PLANNING BOARD REPORT

Commercial Development including gas station and convenience store with ATM

2282 Congress Street

Level III Site Plan and Traffic Movement Permit

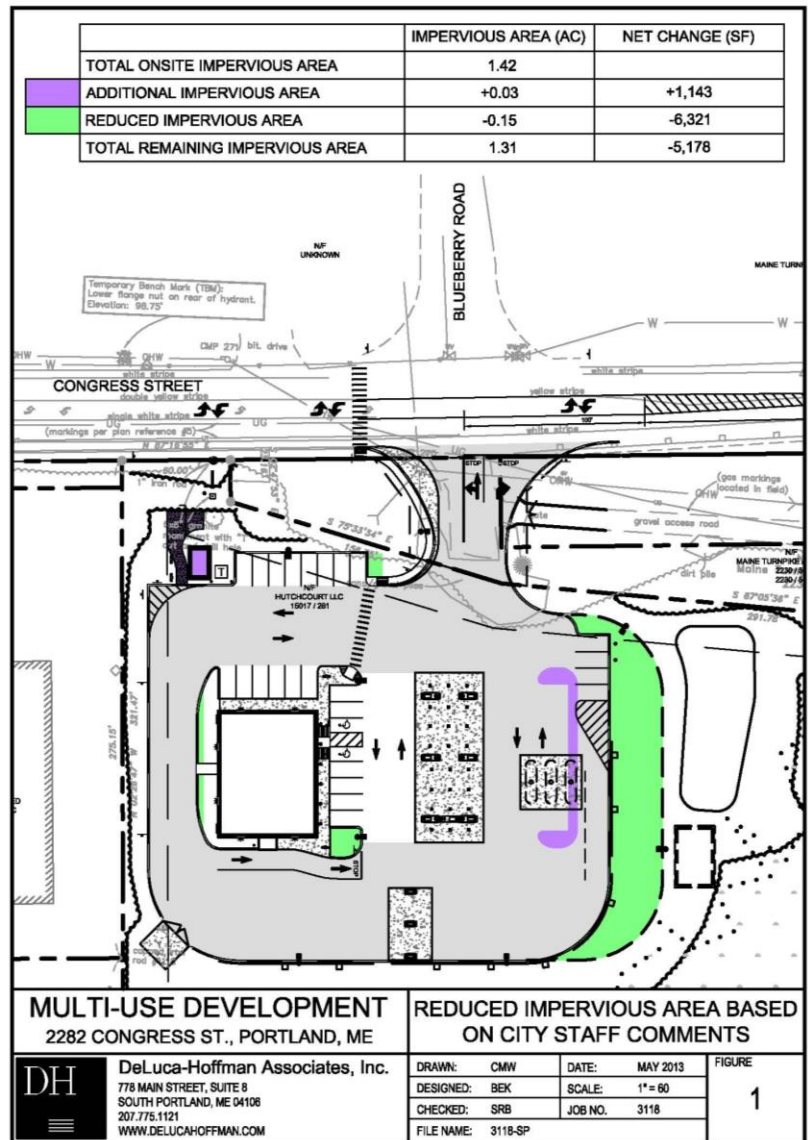
During the review staff raised concerns about the extent of the impervious surface (over 40% of the site), which was designed to accommodate maximum peak parking demand and provide ideal turning areas for very large tractor trailers. Although all of the stormwater run off would be treated, the key issue was that this created an expanse of pavement that was not consistent with the campus-like character required by the CZA.

The applicant reconsidered the parking and truck maneuvering requirements and was able to reduce the impervious area by 7% as summarized in the sketch at right.

Car parking for customers of the convenience store is now at 26 spaces, reduced from 32 spaces in the original site plan. The layout allows for the creation of parking spaces (in the green area of plan to the right) if future peak demand indicates a need for additional parking. Eight bicycle parking spaces are included and a truck parking area.
